Title of theme that you are commenting on

Crouchlands Farm Regeneration – Water Neutrality/Mains Sewage

Loxwood catchment area

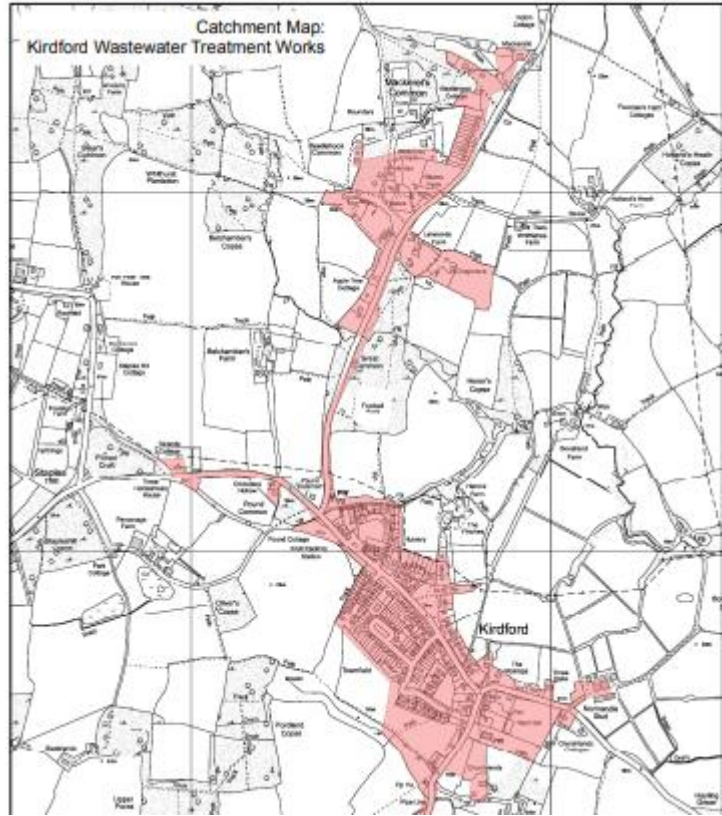
The foul drainage from Plaistow appears to consist of a gravity section in the main village and a pumped section which extends to a distance of approximately ½ mile from the centre of Plaistow at a lower elevation. There is a pumping station located on Rickmans Lane .

Crouchlands farm is located well beyond the pumped section so any connection to the Loxwood mains sewage would involve considerable investment which would need to include a new pumping station and main.
